To: Karen Allston, Senior Assistant Attorney General, Quinault Indian Nation

From: Natural Systems Design, Inc and SaturnaH2O

Date: April 23, 2020

Re: EARTH DISCIPLINE REPORT - GEOLOGY TECHNICAL ANALYSES REVIEW

Figure 1. Shannon and Wilson 2017 Landslide Mapping in FRE Reservoir Area

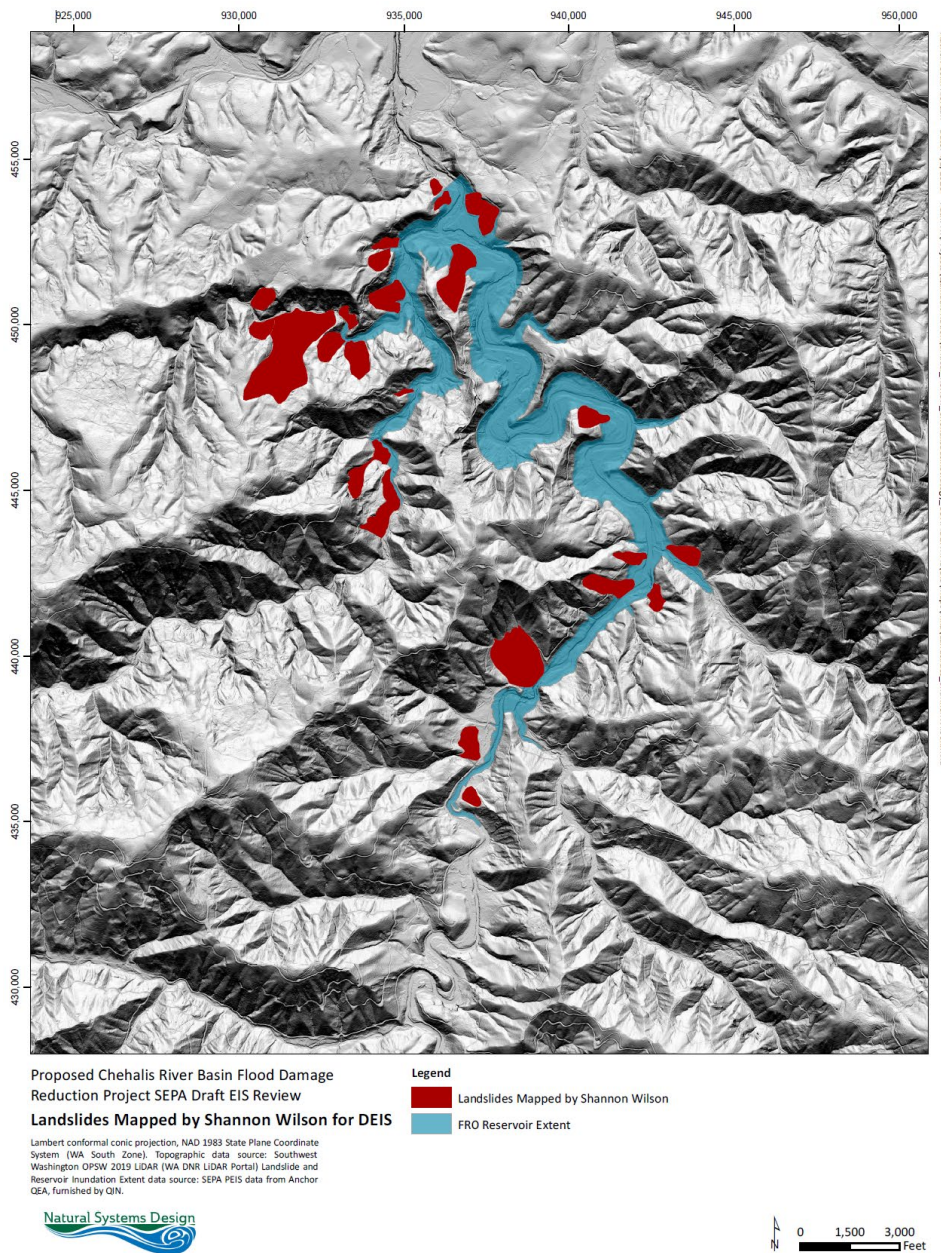
Our review of the landslide mapping by Shannon and Wilson identified omissions of many significant landslides and other mass wasting processes that could impact the FRE dam design, FRE operations, ecological impacts, and impacts to public safety (DEIS Figure F-3). Additional mapping performed by Weyerhaeuser (1994) and WA DNR (Sarikan et al. 2008) and presented in the DEIS (Figure F-5) includes mapping of some recent shallow rapid landslides. It is our opinion that none of these mapping efforts, individually or collectively, are comprehensive and do not accurately represent slope stability conditions, risks, and impacts within the FRE reservoir area. We performed a desktop landslide mapping effort that demonstrates 1) **widespread slope instability** within the watershed, 2) a **greater potential for slope instability** resulting from vegetation removal and fluctuating reservoir levels than was disclosed in the DEIS, and 3) the resulting **underestimation of sediment inputs** into the Chehalis River from landslides.

Figure 1 shows the extent of landslides mapped by Shannon and Wilson (2017). Figure 2 shows landslides mobilized in the 2007 storm and landslide prone areas using SHALSTAB as mapped by the DNR. Figure 3 shows landslides (deep-seated, complexes, shallow-rapid, slumps, and debris flows) mapped by the authors of this memo. Figures 2 and 3 demonstrate that there are significantly more landslides in the areas contributing to the reservoir area than presented in the Shannon and Wilson technical analyses (Figure 1). Figures 2 and 3 also demonstrate that the watershed is very susceptible to slope instability, as evidenced by the pervasive occurrences of landslides throughout the watershed. We observed that shallow-rapid landslides occurred on slopes less than 20 degrees. We also observed geomorphic evidence of retrogressive and sympathetic landslide propagation (e.g. one landslide destabilizes areas above it and a domino of landslides migrating upgradient results). Inundation and drawdown will increase landslide occurrences within the reservoir area and likely increase their magnitude (see Soil Hydraulic Conductivity Analysis below). As a result, there will be more landslides and more sediment delivery to the channel and valley bottom within the reservoir than disclosed in the DEIS. The DEIS calculates 840,500 cubic yards of sediment from landslides potentially influenced by reservoir operation will be contributed to the reservoir as a result of this project (DEIS, page F-64; Figure F-17). The volume calculation assumes that only shallow slides on steep slopes (covering 10% of the reservoir area below the reservoir pool elevation of 627 feet) would be mobilized. However, individual relict landslides mapped by

Shannon and Wilson occurring within 3000 ft of the proposed FRE structure on Crim Creek and the Chehalis River could be influenced by reservoir fluctuations; each of these slides had volumes of in excess of over 200,000 cubic yards; the largest of the Shannon and Wilson mapped landslides has a volume approaching 500,000 cubic yards. These landslides were not considered in the volume estimate. NSD analysis showed significantly more large landslides that Shannon and Wilson mapped; NSD mapped over 20 additional large landslides (45 million square feet of slide area) than the 27 (10.7 million square feet of slide area) landslides mapped by Shannon and Wilson. The Shannon and Wilson mapped relict landslides were not included in the DEIS landslide sediment input volume estimate. The assumption made in the DEIS is that “steep slopes” only below the pool elevation will contribute sediment; an assumption that is false. This assumption does not consider the destabilization of relict deep-seated landslides, new landslides, retrogressive and sympathetic landslides from shallow and deep-seated landslides that migrate upgradient and contribute landslide sediment to the reservoir area and river from above the reservoir pool.

Figure 3. NSD Mapping of Landslides compared to Shannon and Wilson 2017 mapping

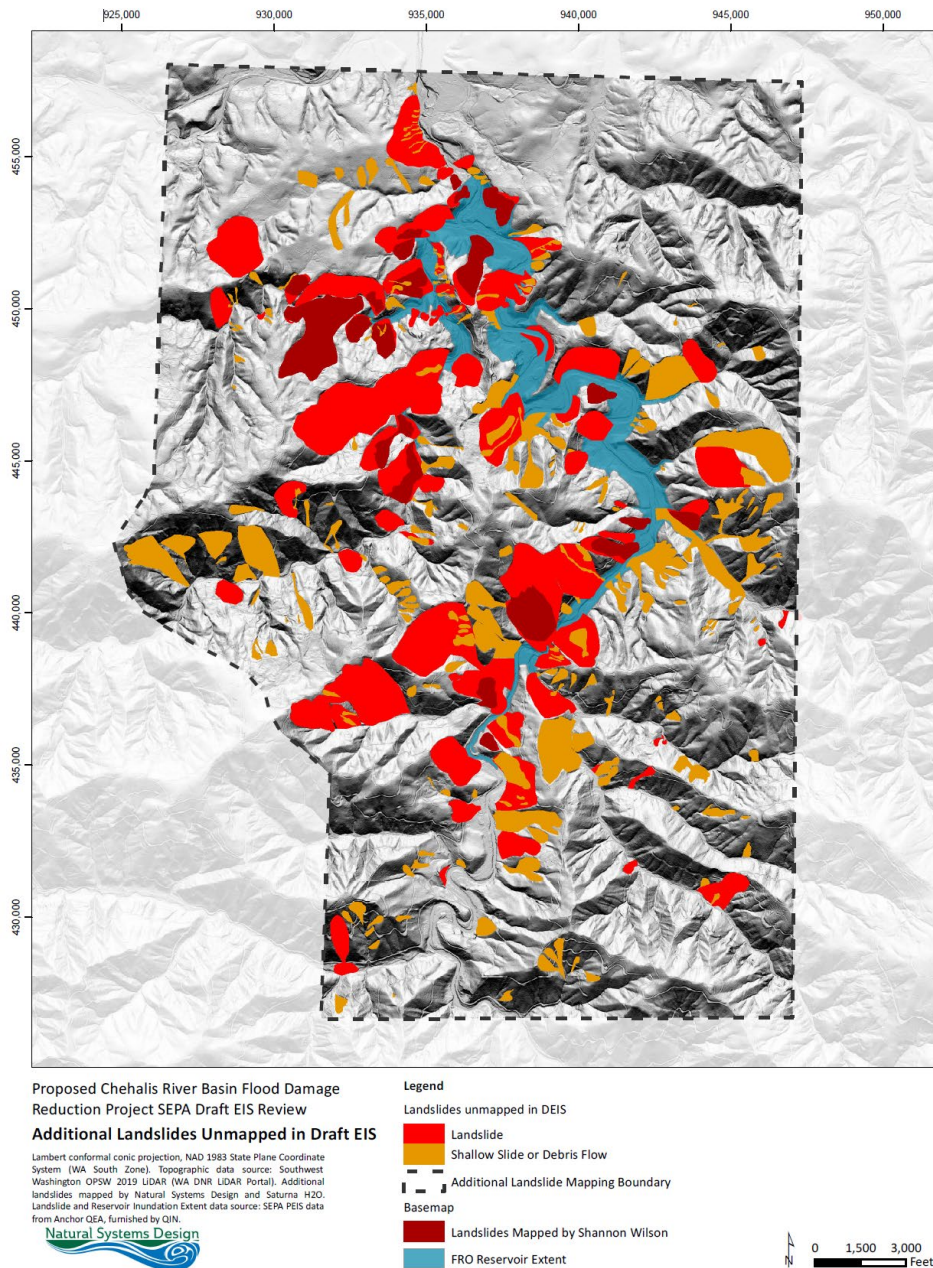
To demonstrate how the DEIS underrepresents sediment volume from landslides influenced by reservoir operations, we utilized NSD landslide mapping to identify relict deep-seated landslides that could be influenced by reservoir fluctuations; this includes landslides where only the toe of landslide deposits was submerged. The premise is that if a landslide toe fails, retrogressive landslides will result (Xia et al. 2014). We also considered the footprints of past shallow landslides and debris flows that contact the FRE reservoir that may have unstable, unconsolidated materials that could be destabilized by inundation and drawdown operations and experience retrogressive failures or remobilization. We calculated the areas of these landforms and then assumed the 6-foot slide depth to maintain consistency with the value used in the DEIS estimate. Our estimate revealed a volume of approximately **15 million cubic yards** (Table 1) of sediment potentially delivered to the FRE reservoir area from landslides compared to the volume of approximately **840,000 cubic yards** estimated in the DEIS.

While this volume may over estimate potential sediment delivery in that it assumes every slide becomes mobilized, it is used to contrast the under estimated value from the analysis used in the DEIS which assumes no historic slides will be destabilized or that there would be no retrogressive landslide propagation resulting from slope failures upgradient of the FRE reservoir pool. The volumes presented in Table 1 do not include the potential sediment delivery estimate from steep slopes calculated for the DEIS; therefore, the **total volume of sediment potentially delivered to the Chehalis River by FRE reservoir operations could exceed 16 million cubic yards**. The DEIS estimated volume would be in addition to the volumes estimated in Table 1 from relict landslides.

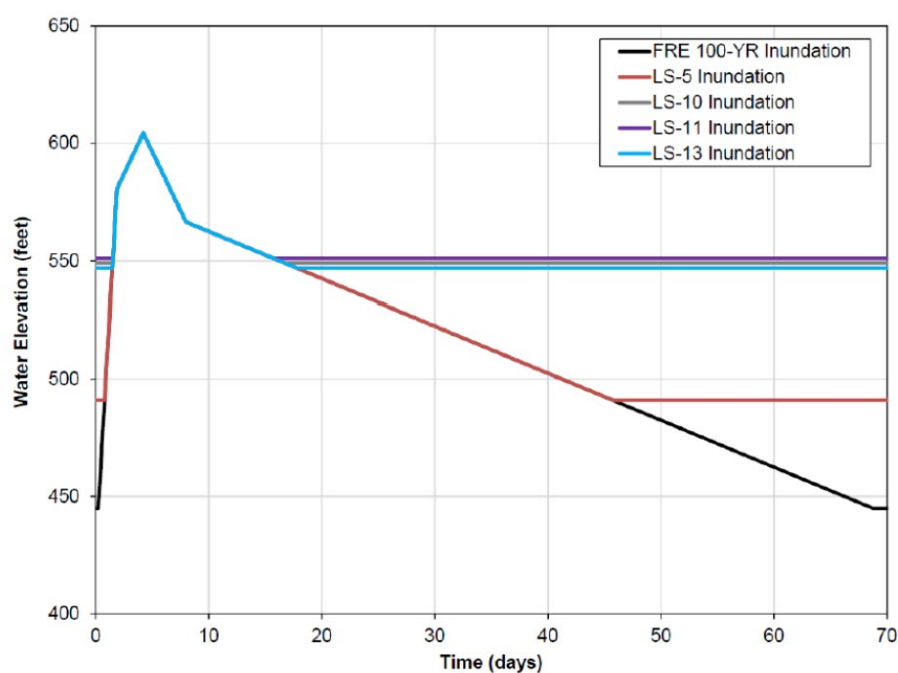
We observed that the drawdown curve used in the Shannon and Wilson analysis is different than is proposed in the DEIS. Shannon and Wilson modeled a 10 ft/day initial drawdown for approximately 4 days following full pool (pool elevations ~605 feet to 565 feet) and then a 2 foot per day reduced drawdown rate until full pool evacuation (approximately 60 days) as shown on the graph below from Shannon and Wilson (2019) (Exhibit 2).

The FRE Operations Plan stated in the DEIS differs from what was analyzed by Shannon and Wilson (2019) for slope stability. The operation conditions analyzed by Shannon and Wilson would have less impact on slope stability conditions than the conditions proposed in the DEIS. For example, 1) the maximum water elevation is higher in the DEIS than was analyzed and 2) the drawdown rate is more rapid in the DEIS (approximately twice as fast). The Shannon and Wilson analysis needs to model the proposed operation conditions to understand the potential for slope instability; however, the potential for instability caused by reservoir operations will be greater than what was disclosed in the DEIS. The differences are shown in Table 2.

If the drawdown rates in the Shannon and Wilson analysis are correct, the slopes will be susceptible to failure during drawdown (e.g., Schuster 1979, 2006, Riemer 1992, Paronuzzi et al. 2013, Yin et al. 2016). If the drawdown rates stated in the DEIS are correct, the slopes will be VERY susceptible to failure during drawdown as they are more extreme than the conditions analyzed by Shannon and Wilson. The drawdown rate proposed in the DEIS is very aggressive and the water stored in the soil during high-pool cannot drain quickly enough; the excess pore-water pressure at the base of the soil will induce seepage and result in widespread slope failures. Reservoir management often considers rates of more than one foot per day as rapid, for example the Indiana Dam Safety Inspection Manual, New Jersey Dam Safety Standards, Pennsylvania Division of Dam Safety, and South Carolina Dams and Reservoirs Safety Act Regulations all state that pool level drawdown rates should not exceed one foot per day.

Figure 7. Location of the likely landslide dam that occurred on the Upper Chehalis River during the December 2007 flood.

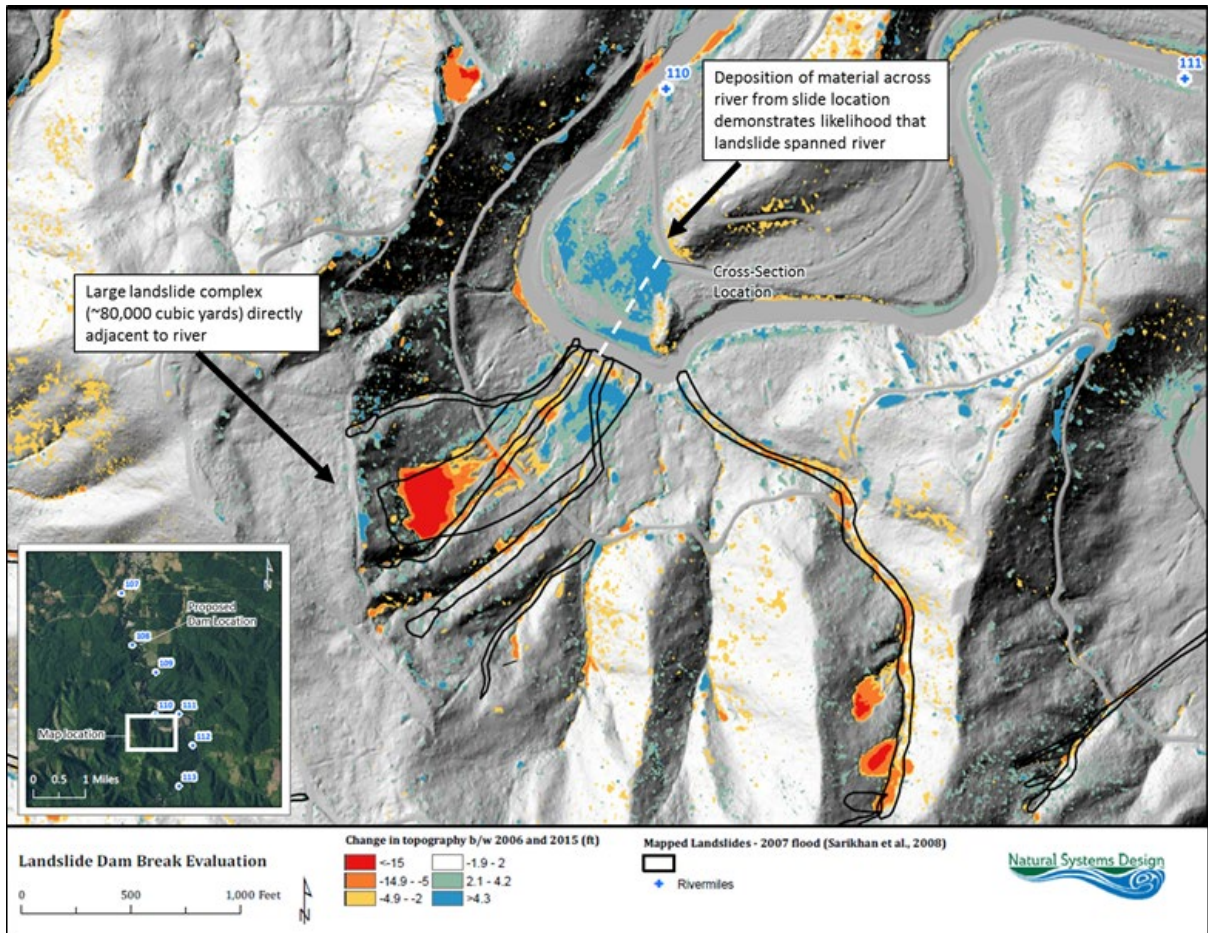
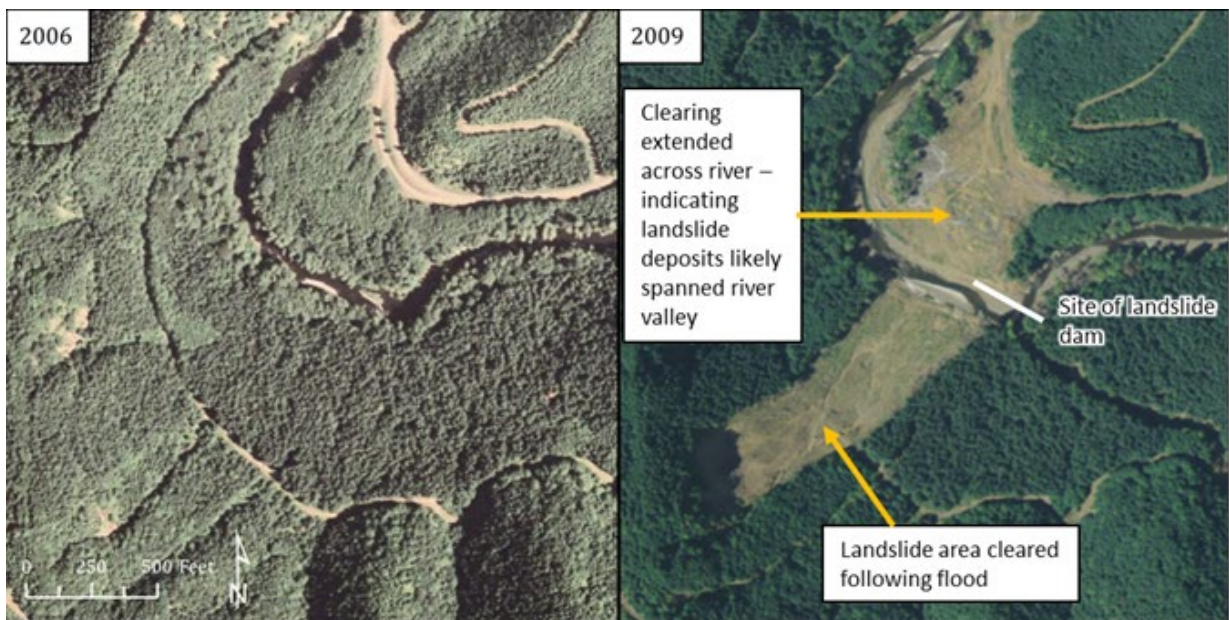
The results of the landslide analysis revealed one location where a landslide/debris flow that occurred during the 2007 flood likely dammed the Chehalis River (Figure 7). A large landslide/debris flow complex was mapped by DNR along the left bank hillslope of the Chehalis river near RM 110.5. The complex initiated near a convexity in the hillslope roughly 600 ft in elevation above the river and extended ~1,200 ft downslope to the valley bottom. The complex consists of a large mapped landslide and three adjacent mapped debris flows. Topographic change analysis indicates that the landslide eroded roughly 80,000 cubic yards of material from the hillslope and deposited it across the valley bottom. This is supported by evidence of 2-10 ft of deposition that occurred on the terrace across the river valley from the landslide complex in addition to deposition at the toe of the landslide complex itself on the left bank of the river. The matching depositional surface indicates that the landslide deposit likely spanned the entirety of the valley. This conclusion is supported by aerial imagery which shows cleared landslide deposits on both sides of the river in 2009 – 2 years after the 2007 flood (Figure 8).

The topographic change analysis was used to estimate that the landslide complex was capable of creating a 20 ft high and 40 ft wide dam 250 ft across the Chehalis River valley (Figure 9 and Figure 10). A landslide of this magnitude would have likely created a temporary barrier to flow in the Chehalis River, effectively acting as an embankment dam. Though the mass of landslide complex could resist the hydrodynamic forces to impound a reservoir, this unconsolidated material is highly erodible. A likely probable failure mechanism of an embankment dam is rapid erosion and subsequent head cutting and mass failure of sides slopes through the embankment structure, due to overtopping flows. The December 2007 flood event had the requisite characteristics to create such an event.

Figure 12b. The conduits of the FRE as designed are unlikely to pass the size of wood material moving down the river. Illustration shows typical wood scaled to the conduit entrances.

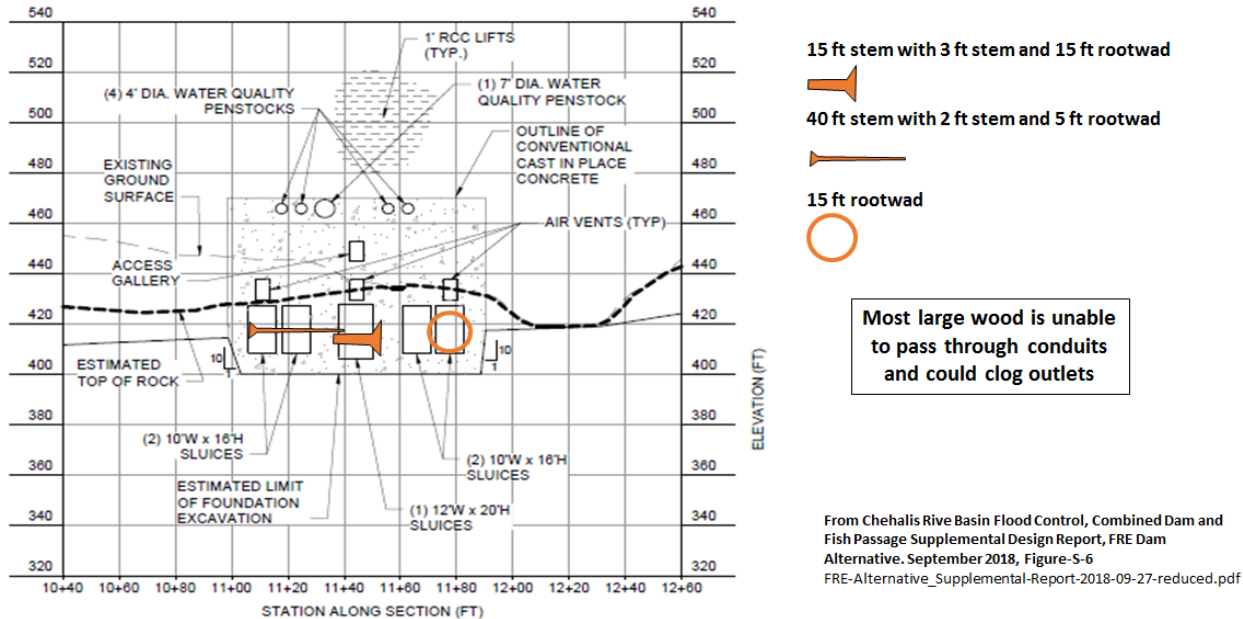
The flood wave caused by breaching of a landslide dam would have the potential to cause significant damage to the proposed FRE structure. The wave would likely contain a mixture of landslide debris such as large logs/trees, boulders, and a range of sediments all suspended in flood waters (Figures 12a and 12b). The material has the potential to damage the trash-rack and conduits intended to pass river flow – maybe even clogging the structures and preventing flow from passing at all. Coarser sediment carried by the flood wave than what is typically transported by the river would likely damage the conduits themselves. The impacts would be increased if the landslide dammed the river during a flood in which river levels were elevated but below the threshold for dam closure as the conduits and trash-rack would already be responsible for passing elevated water and debris levels.
